Midway City Council  
4 August 2020  
Regular Meeting

Huntleigh Woods Subdivision /  
Preliminary Approval

**CITY COUNCIL MEETING STAFF REPORT**

**Subject: Huntleigh Woods Preliminary Approval**

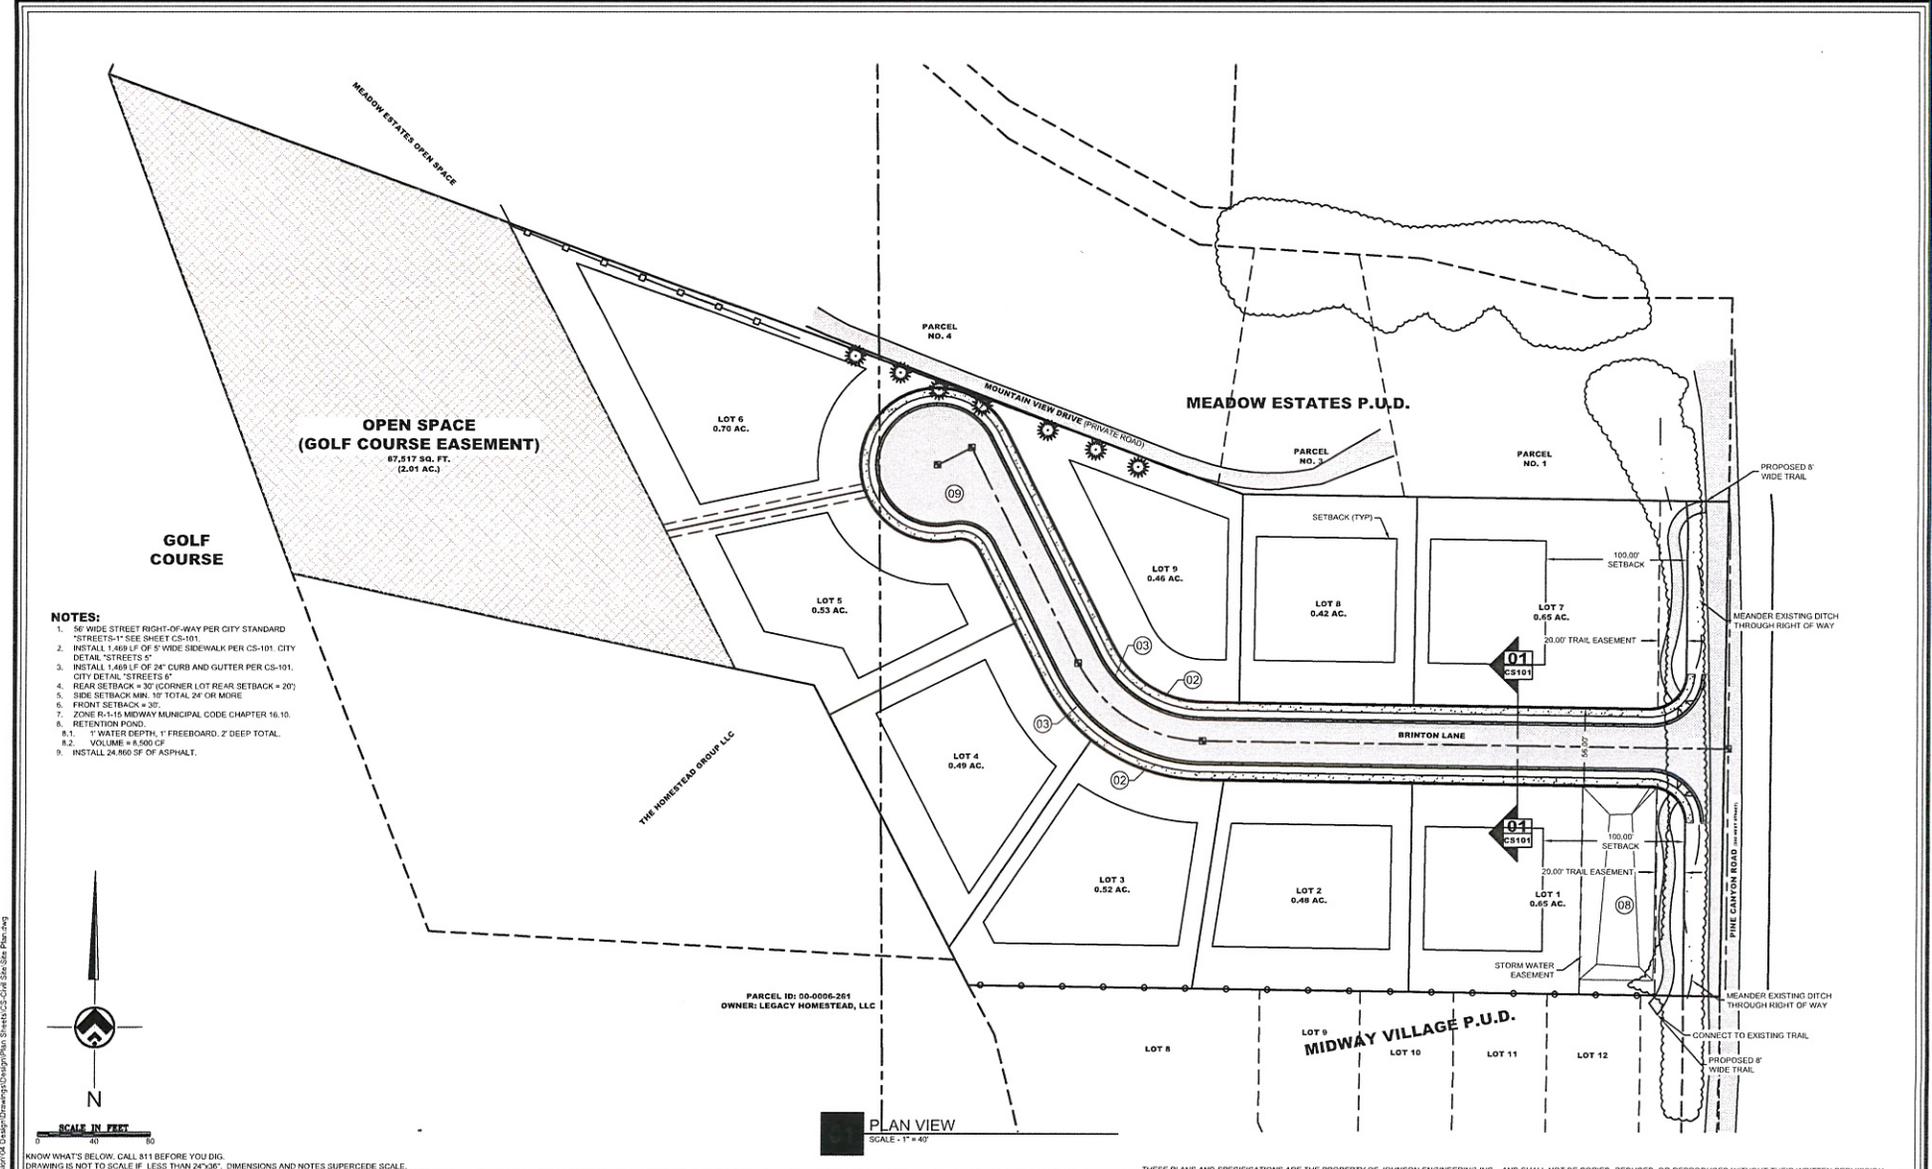
- The plans propose to develop 9 lots on approximately 8.10 acres near 700 North Pine Canyon Road.
- All redline comments within the preliminary plans should be addressed.
- A geotechnical report will need to be submitted.

- The proposed development will be served from the Gerber Mahogany Springs zone.
- The proposed development will connect to the existing 10" water line in Pine Canyon Road.
- The fire hydrant spacing shall not exceed 500'.
- Existing 12" transite water line that runs through the proposed subdivision will need to be removed and the Homestead maintenance shed water lateral be re-established.

- The proposed development will connect to existing irrigation in Pine Canyon Road and will need to install services with meters according to Midway Irrigation Company standards.

- The proposed road within the development will be a 56' public right-of-way, with a cul-de-sac at the west end of the development.
- Cross section for right-of-way will be 30' of asphalt, 2' curb and gutter, 6' park strip, and 5' sidewalk.

- The proposed development will connect onto Midway Villages trail to the south and will end at the north end of the development.

- The storm water system within this development will be a public system. The storm water will be addressed through the use of sumps and retention basins.
